# Chestnut Hill Avenue

## Responses to Transportation Board Feedback

Brookline Transportation Board Meeting

September 16, 2026

# Reservoir Station Crossing

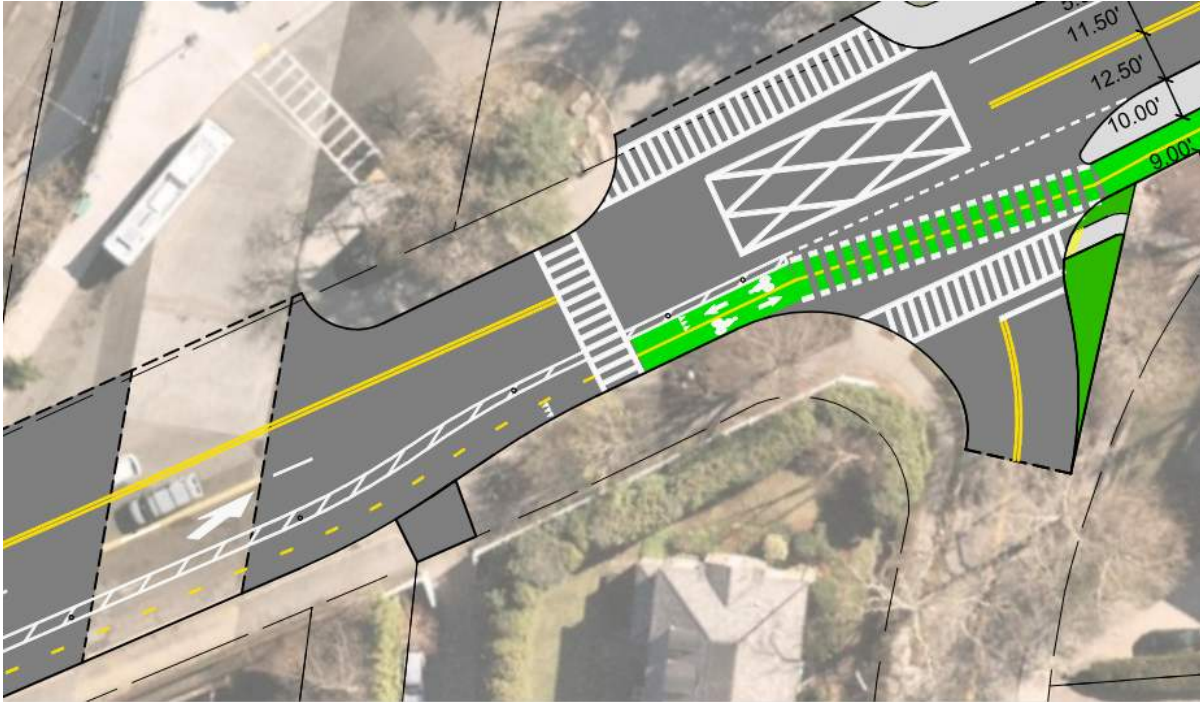
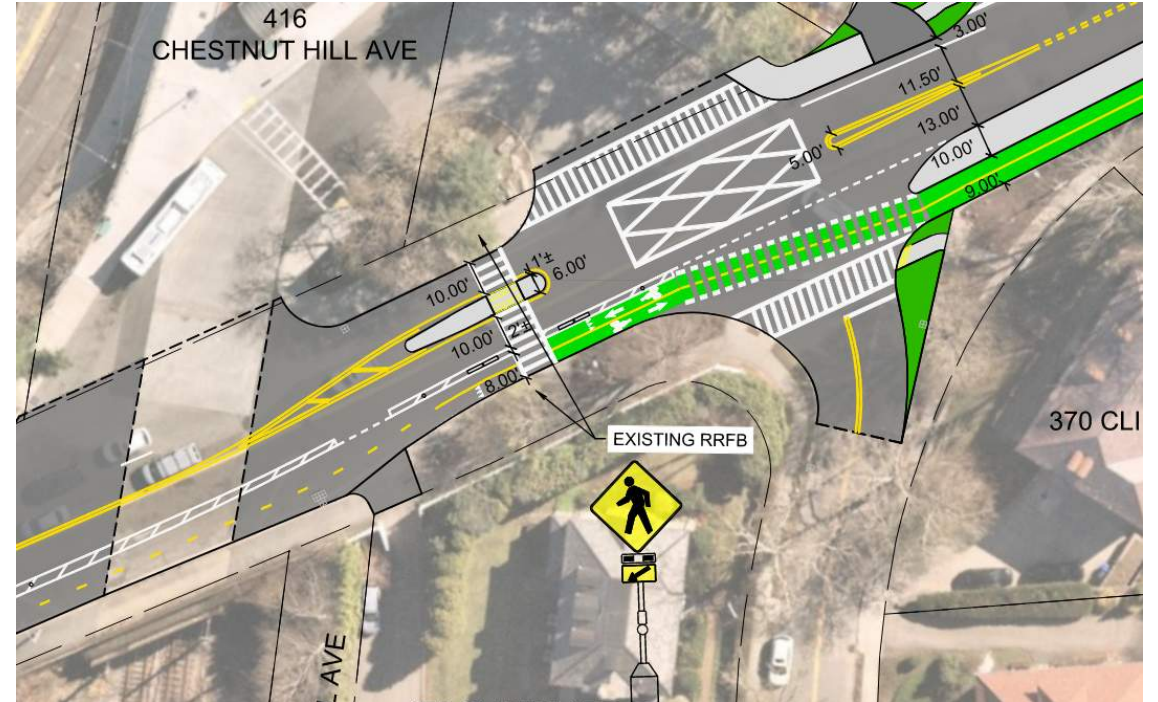
- Pedestrian refuged island added
- Distance that pedestrians cross at one time shortened
- Crossing geometry to be refined during subsequent design

# Cycle Track Separation Treatment

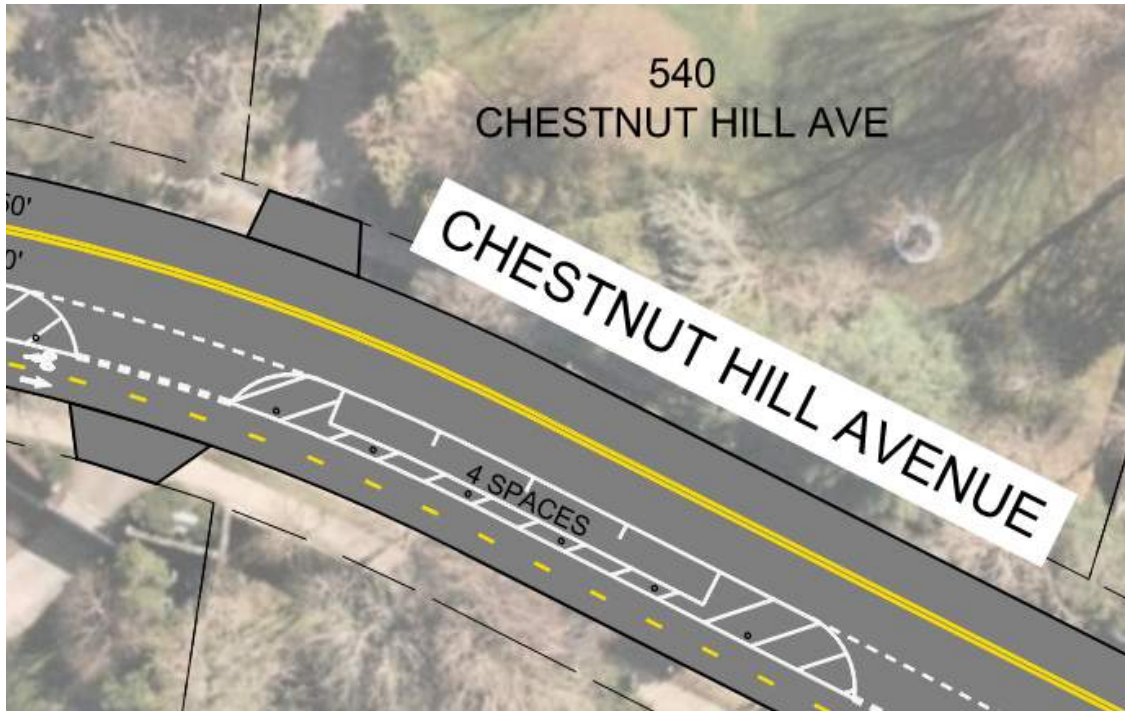
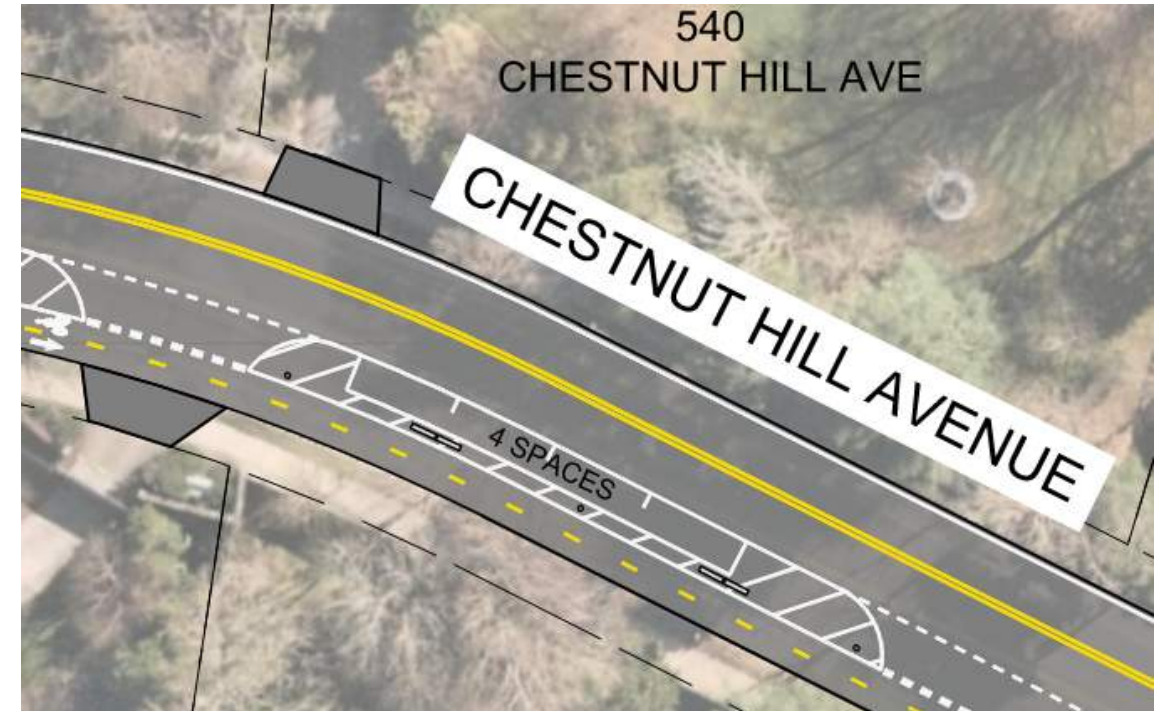
- Alternating precast curb units with flexible delineators and flexible delineators
- Provides physical separation within the 3-foot buffer
- Final product and spacing to be determined during design

# Route 9 Existing Queue Observations

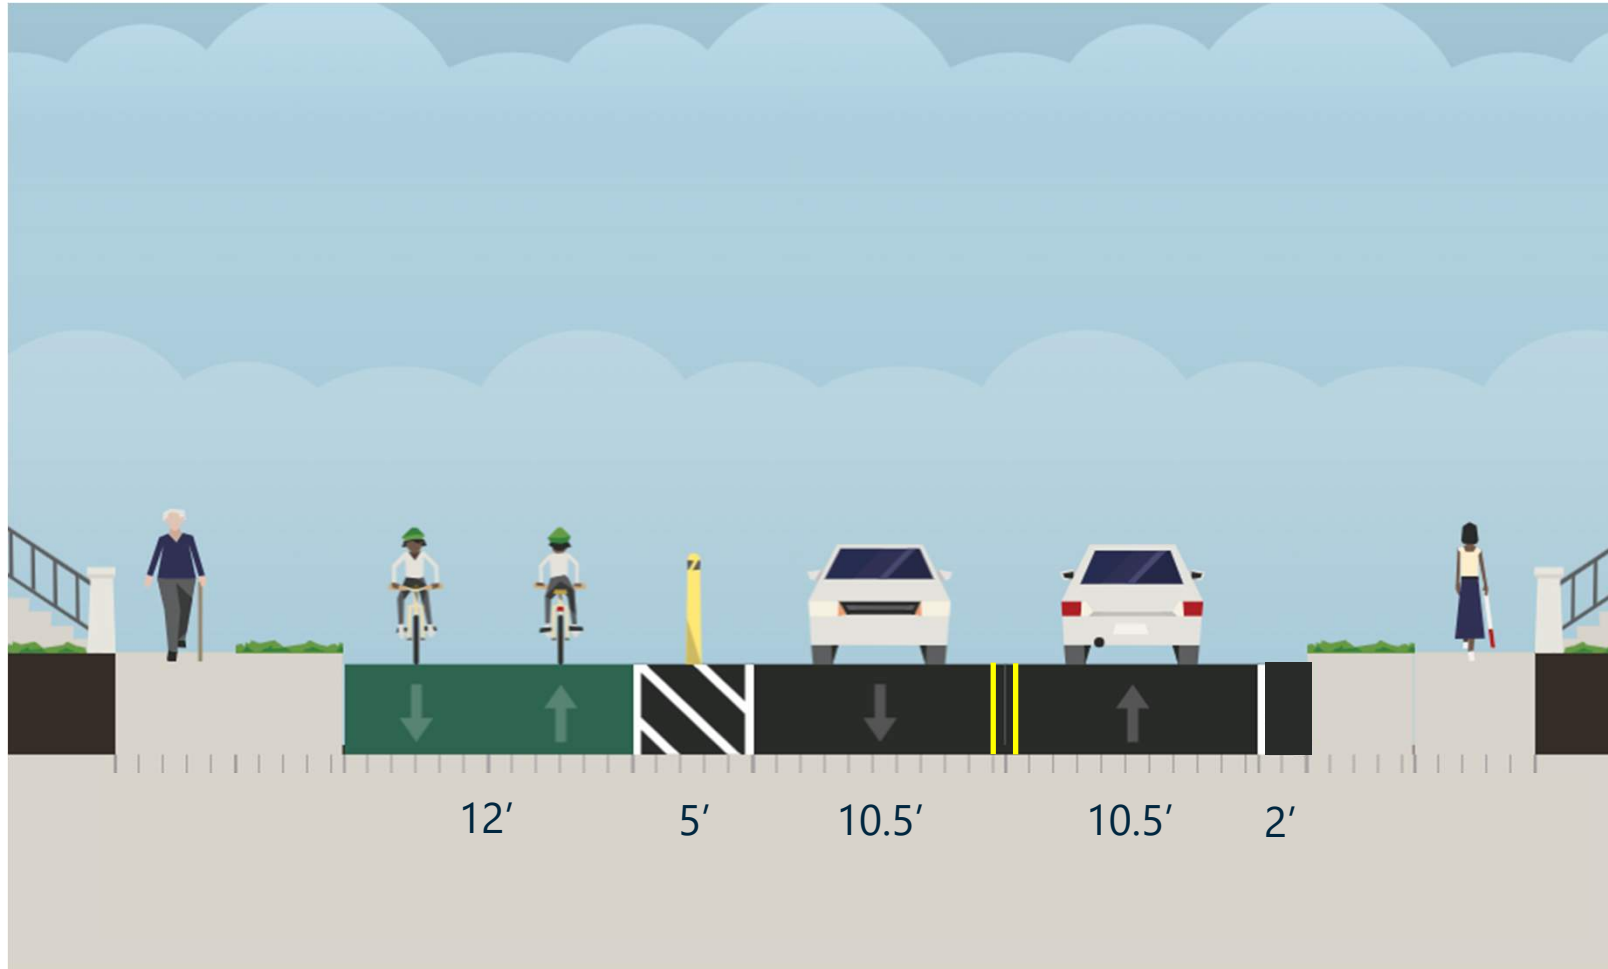
- Longest queue observed in reviewed aerial imagery occurred on October 3, 2023
- No other reviewed aerial image showed a queue extending beyond Channing Street
- Aerial observations do not establish average of 95<sup>th</sup> - percentile queue lengths
- Detailed traffic analysis would be required to confirm design queue lengths
